AMENDMENTS TO THE DRAWINGS:

FIG. 1

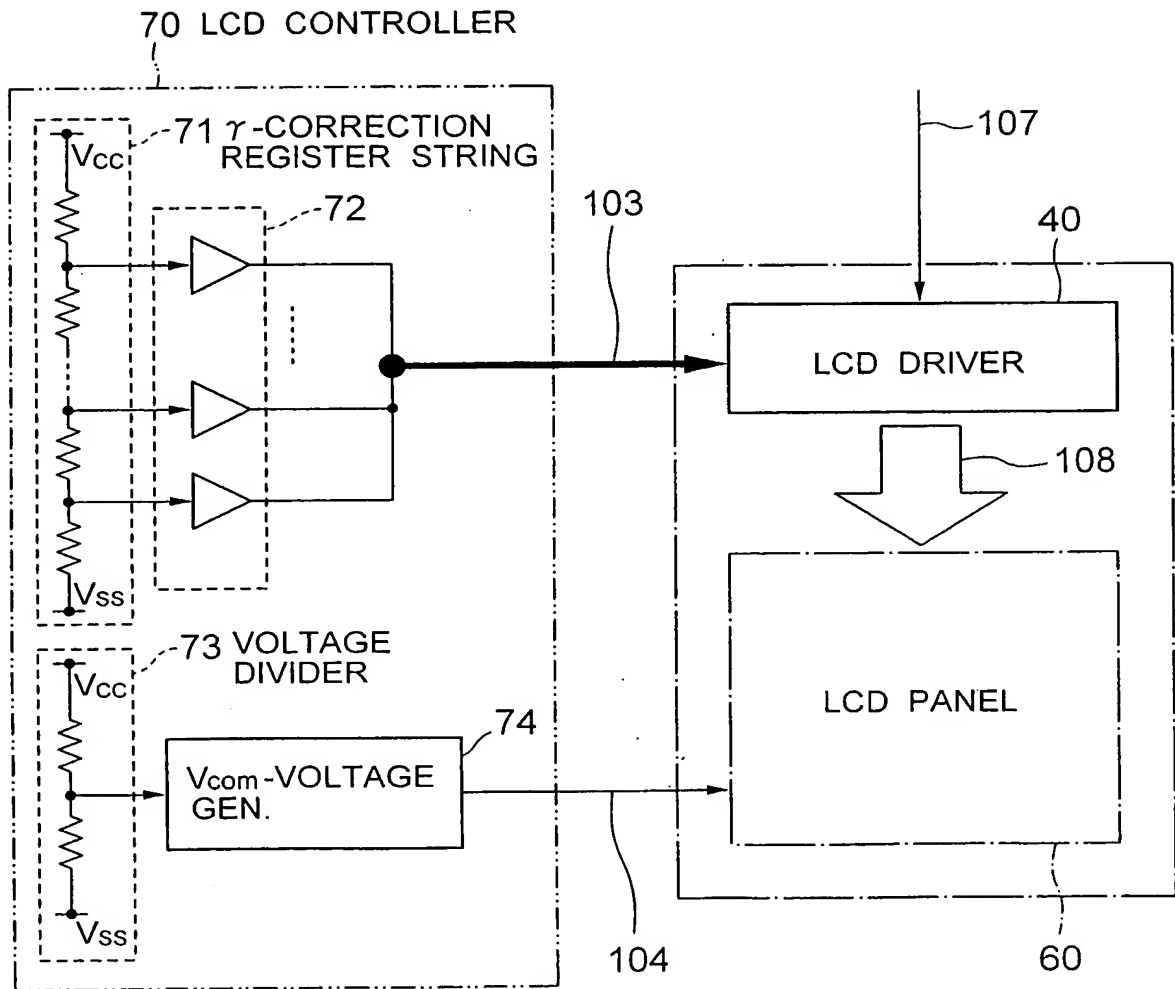
Replacement Drawing Sheets 1, 2, 3 and 5 are attached hereto as an appendix and contain revised Figures 1, 2, 3 and 5. In Figure 1, Applicant has added a "Prior Art" legend. In Figure 2, Applicant has corrected typographical errors in the words "control" of element 10 and "polarity" of element 106. In Figures 3 and 5, Applicant has clarified reference numerals with appropriate sub-notations so as to correspond with the specification, as required by the Office Action. For example, in Figure 5, Applicant has amended the reference numerals of the latches and decoders to read 40_1 and 41_1 , 40_2 and 41_2 , etc.... Further, Applicant has corrected the reference numerals of the operational amplifiers to read correctly $43_1 \dots 43_j$ (instead of $A3_1$ etc...) as noted on page 14, lines 3-6 of the specification. Applicant submits that no new matter is added by these amendments.
